Docket Number:	17-BSTD-02
Project Title:	2019 Title 24, Part 6, Building Energy Efficiency Standards Rulemaking
TN #:	223341
Document Title:	Whirlpool Corporation Comments On 2019 Title 24, Part 6, Building Energy Efficiency Standards Rulemaking
Description:	N/A
Filer:	System
Organization:	Whirlpool Corporation
Submitter Role:	Public
Submission Date:	5/7/2018 2:07:37 PM
Docketed Date:	5/7/2018

Re: Docket No. 17-BSTD-02 for 2019 Title 24, Part 6, Building Energy Efficiency Standards Rulemaking

Section 150.0(o)1(G) - Kitchen Range Hoods Sound Rating

Figure 1

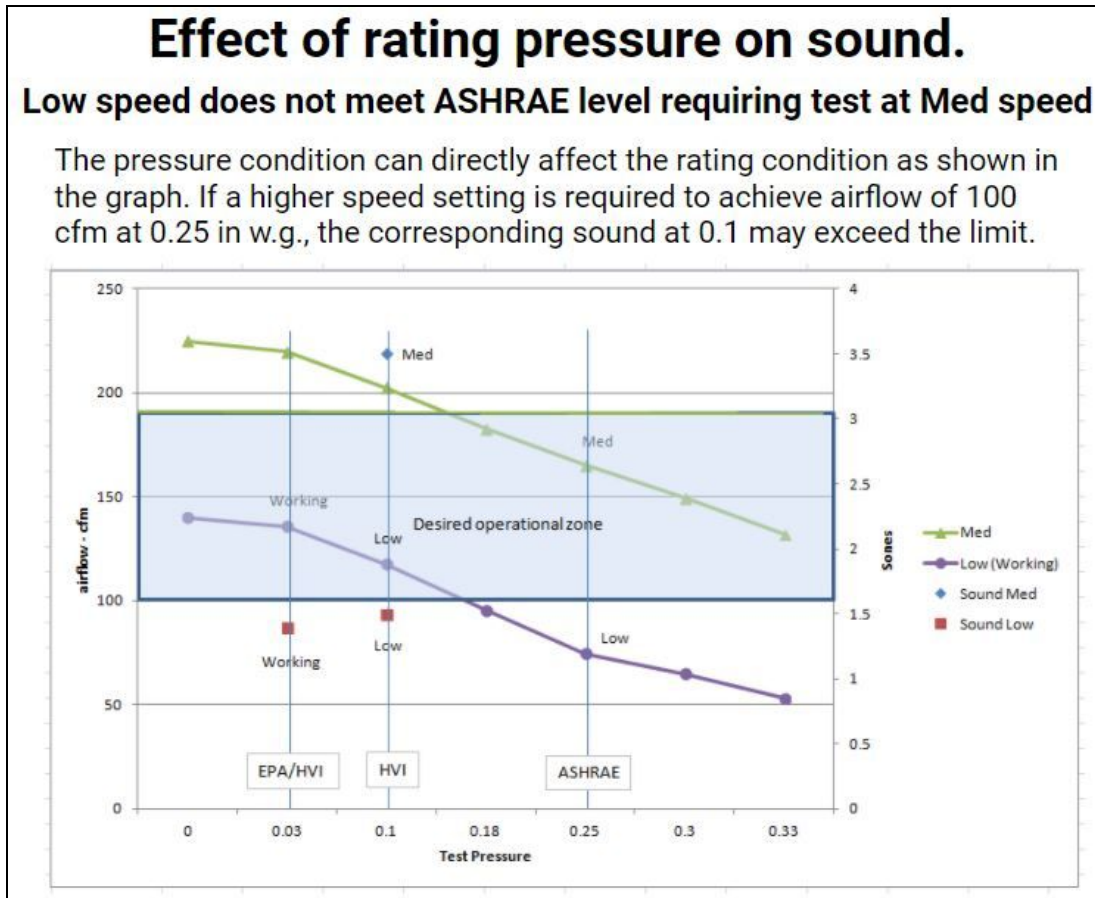
According to ASHRAE 62.2 the sound measurement is conducted at an airflow rate of 100 cfm minimum that is measured at a pressure of 0.25 in w.g. The exception to allow HVI "Working Speed" modifies the test condition for airflow measurement to 0.03 in w.g (typical). Please see the graphical representation in Figure 1 below.

The proposed modification would alter the language to allow for the acceptance of ratings conducted at a more stringent test condition, specifically 0.1 in w.g. This additional test condition is the standard condition under HVI 916 that is applied to the rating of the high speed and other designated speeds such as low speed and has available sound data.

EXCEPTION to Section 150.0(o)1G: Kitchen range hoods may be rated for sound at **any speed that delivers 100 cfm or greater** ~~a static pressure determined at working speed~~ as specified in HVI 916 section 7.2.
